Access Compliance Report

Public Rights-of-Way

(Pedestrian Signals)

Intersection ID: N/A	Main Street:	Cross Street: N/A	Location: N/A
ADA ID: 826E4286C73B	Signal Type: Two Push Buttons-Non APS	Overall Compliance: No	Severity Score: BTN 1:N/A BTN 2: N/A No BTN: N/A
Codes/Mitigation Info/Possible Solution		Field Measurements/Component Compliance

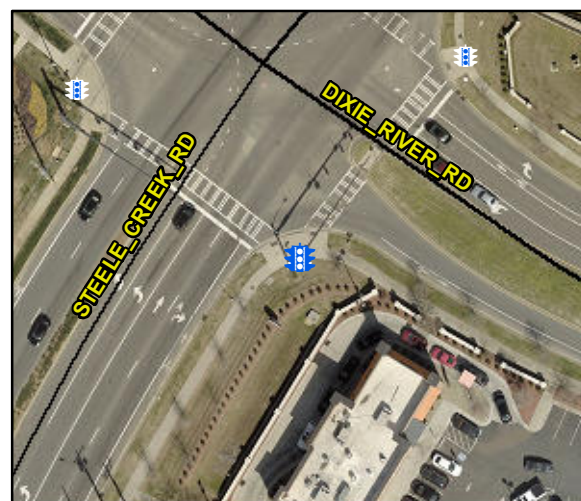
PROW/ADA: TMUTCD 4e.08, R406.2

Possible Solutions: Replace Signal Push Button With APS Button on New Post. Remove & Relocate Sign.

Total Cost: \$ 1300.00
